JTD318 FW upgrade to correct name saving issue

J318 Current Web GUI version V2.01

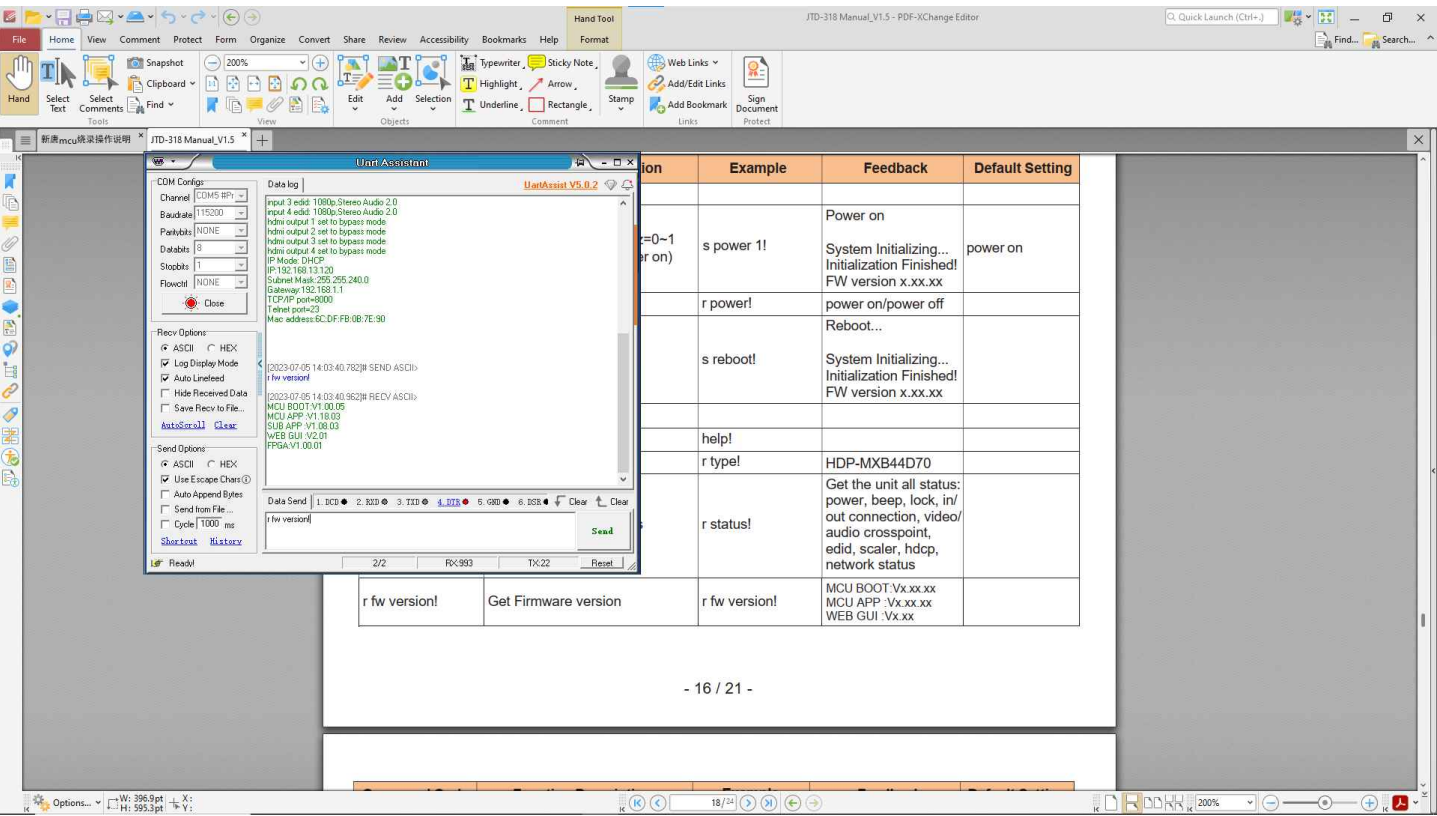
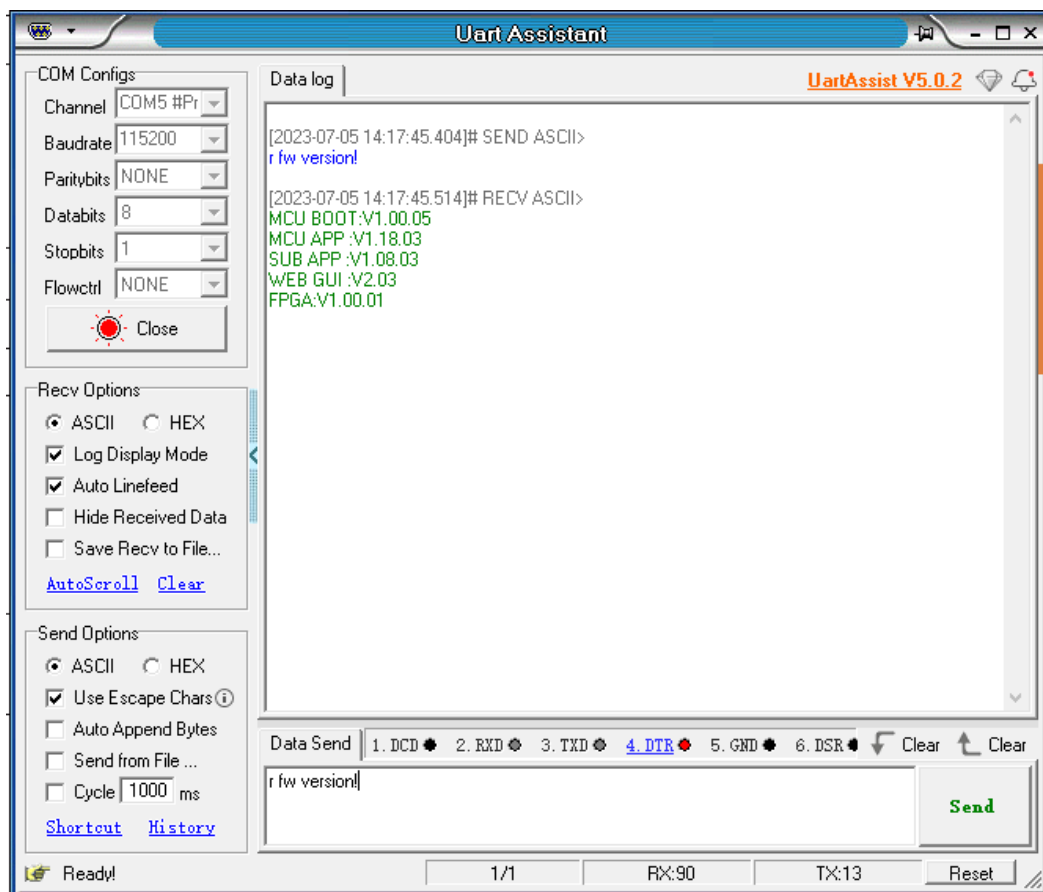
There is an issue with name saving as shown below:

New FW upgrade Web GUI to V2.03:

After upgrading, both input and output names are saved correctly.
